CERTIFICATE OF APPROPRIATENESS

Property: 1407 Tulane Street, lot 15, tract 14, block 152, Houston Heights Subdivision. The property includes a historic 1,370 square foot, one-story wood frame single-family residence and a detached garage situated on a 6,600 square foot (50' x 132') interior lot.

Proposal: Alteration – Revision. Replace non-original porch columns, door and gable windows.

EAST ELEVATION – FRONT FACING TULANE

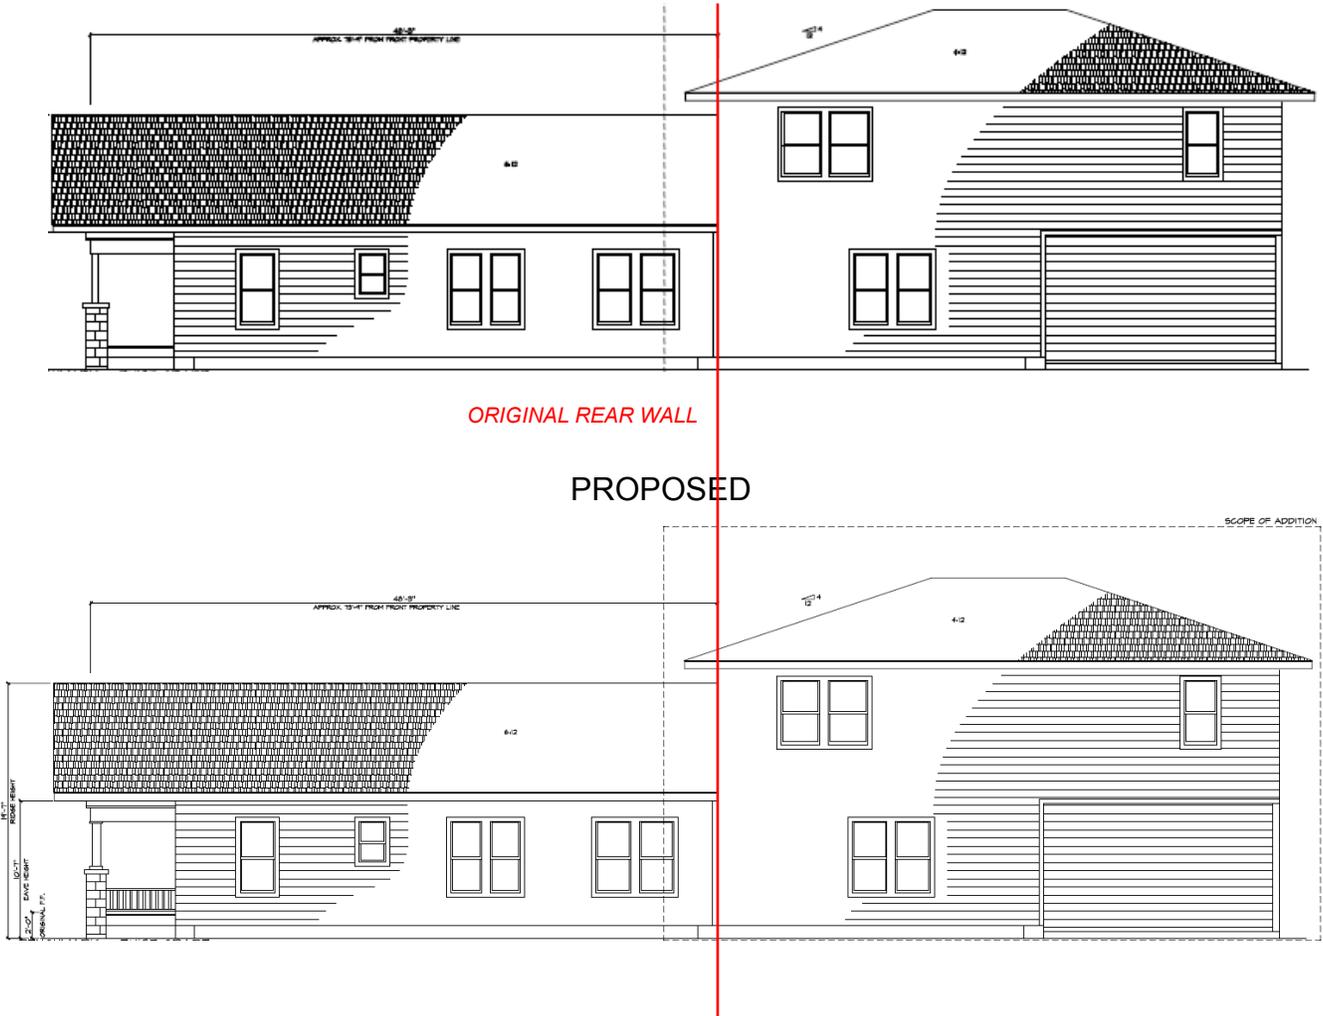
October 2015: The residence features a full width front porch. The columns that support the roof are situated on top of concrete plinths. The two end plinths will be topped by paired columns while the interior plinths will be topped by single columns. Three 1-over-1 windows will replace the fixed windows previously installed in the front gable. See drawings for more detail.
